To:	Lucie Turner	From:	Drainage Team (Arun Govind T)
------------	--------------	--------------	-------------------------------

Planning App Ref:	PL/2026/01249
Service Ref:	Drainage
Date:	30/04/2026

Construction of Bellmouth Access to Melksham Substation from Westlands Lane.

Figure 1

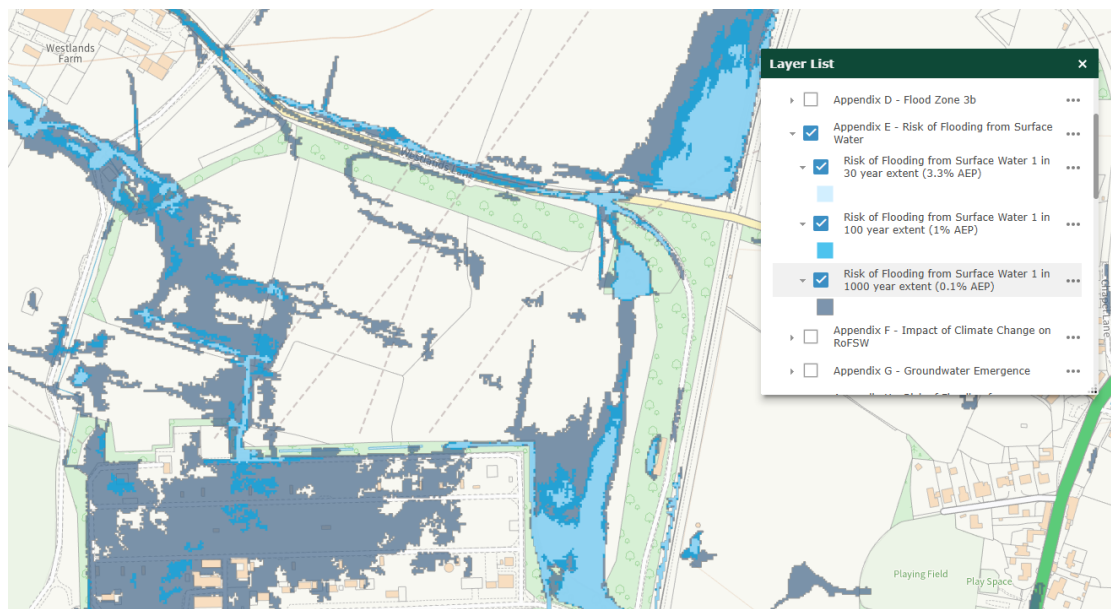
The site is located within Flood Zone 1 and there is a low level of risk from fluvial flooding. The site has a high level of risk from surface water (Figure 1) and ground water flooding (Figure 2).
